HISTORIC PRESERVATION COMMISSION

REQUEST FOR CERTIFICATE OF APPROPRIATENESS

MPC File No.: 26-002756-COA

Address: 414 West 40th Street

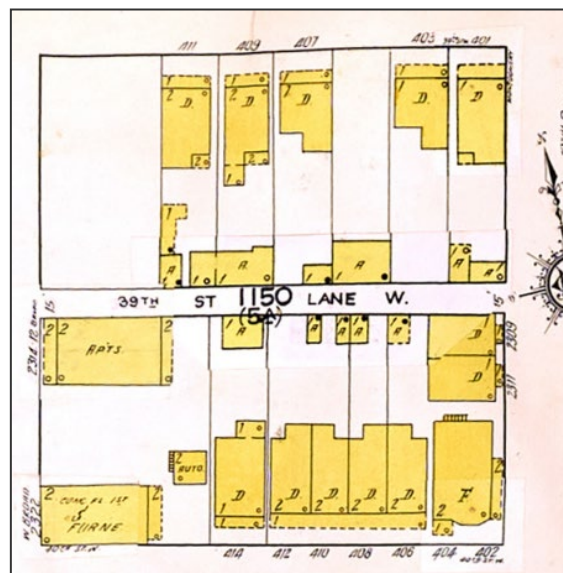
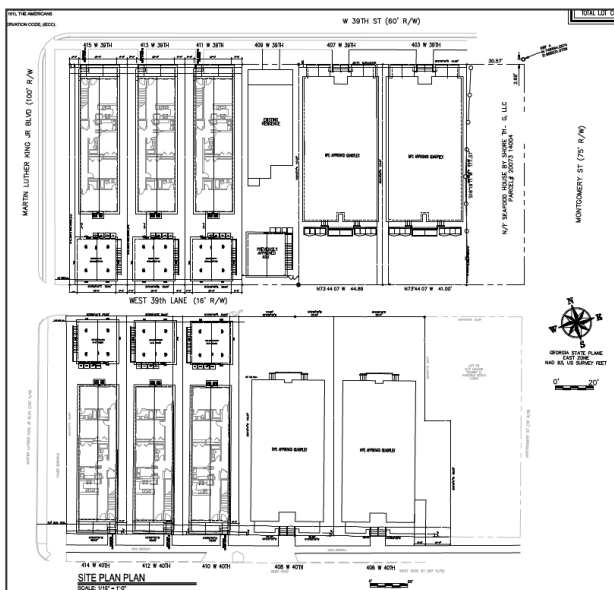
The proposed streetscape below shows the three two-story duplexes in a row similar to the Sanborn Map, bringing a sense of rhythm back to the mostly empty side of the street. As noted with the same project on West 39th Street, this is part of a larger effort to revitalize the MLK Corridor and is within an enterprise zone aiming to bring commercial and residential developments and rehabilitation back to this area.

The site plan below shows the overall proposed and some previously approved new construction to be seen on both West 39th and West 40th Streets. For comparison, the 1953 Sanborn map of both streets showing the earlier development pattern that has largely been lost.
